**GLOBAL STAKEHOLDER CONSULTATION FORM FOR
PROPOSED NEW BASELINE AND MONITORING
METHODOLOGY OR METHODOLOGICAL TOOL
(version 01.0)**

<i>Name of submitter</i>	Daniel Galván Pérez
<i>Affiliated organization of submitter (if any)</i>	Independent Advisor / Consultant
<i>Email of submitter</i>	Danigalvan@hotmail.com
<i>Reference number of proposed new methodology or methodological tool</i>	A6.4-PMM011 – Low Carbon Intensive Hydrogen
<i>Based on an assessment of information in the A6.4-FORM-METH-002 and its application in sections A to C of the submitted draft project design document (A6.4-FORM-AC-020), provide your comments to the proposed new methodology using the tabular format below. Please indicate the sections or issues to which your comments refer to.</i>	
<i>Date received by the secretariat</i>

Figure 1. Hydrogen value chain and relevant boundaries for baseline assessment

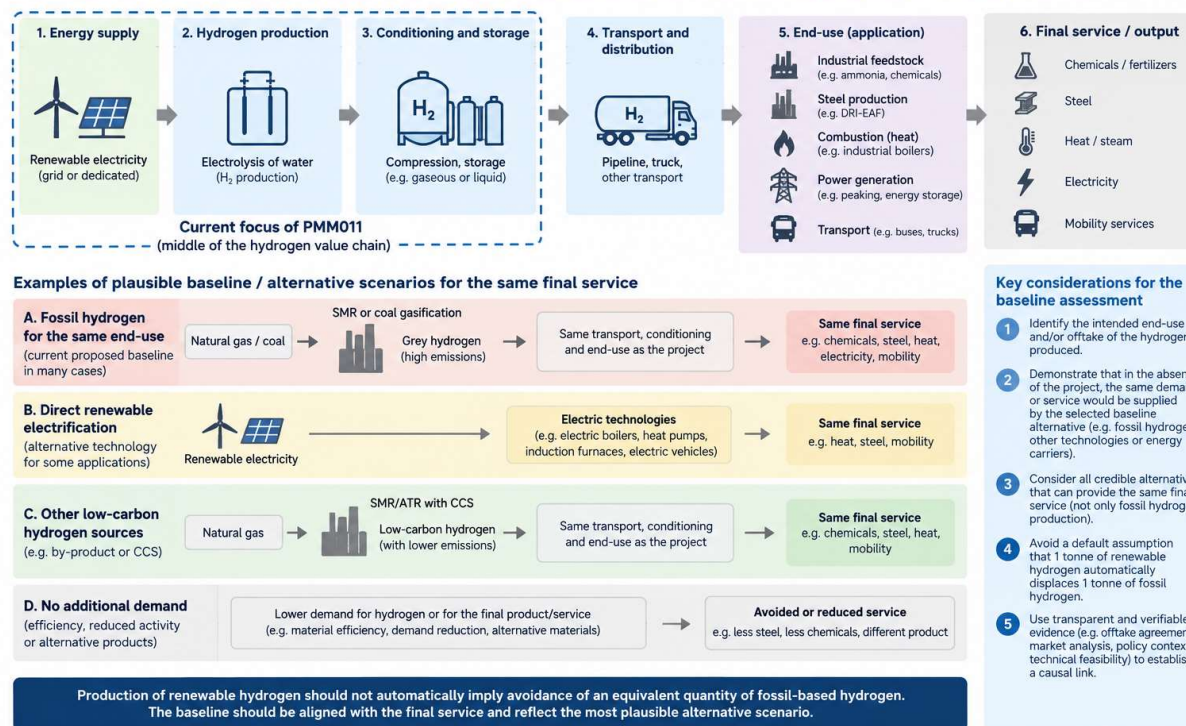
A comprehensive assessment should consider the full value chain and credible alternative ways to provide the same output or service.

Illustrative diagram accompanying comments 1–4. It highlights that baseline assessment should consider the intended end-use and final service, as well as credible alternatives across the hydrogen value chain, rather than focusing only on hydrogen production.
(Please add rows as required)
